Joint Meeting of the RID Committee of Experts and the Working Party on the Transport of Dangerous Goods Geneva, 21 September – 1 October 2021 Item 2 of the provisional agenda Tanks

Comments on document ECE/TRANS/WP.15/AC.1/2021/36 - Mandatory fitting of safety valves to tanks carrying flammable liquefied gases

Transmitted by the International Association of Fire and Rescue Services (CTIF)

1. Display on orange plate (proposal 2 for new 5.3.2.3.3)

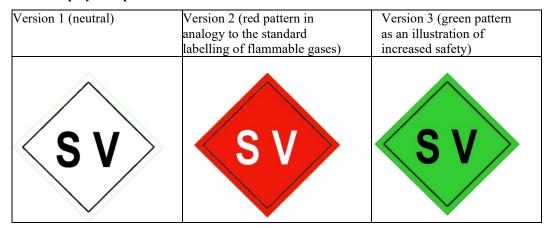
Obviously, this approach has the advantage that the information is readable from a distance. It has the disadvantage that it will go together with an increase of the list of Hazard Identification Numbers (HIN) with the special meanings. Leaflets, instruction sheets, guides, etc. would have to be updated accordingly. This would also create immediate training needs of all first responders independently of their competence level (see 2a) and the number of tanks fitted with safety valves. Furthermore, this option will not go well with countries using the Emergency Action Code (EAC) instead of the HIN
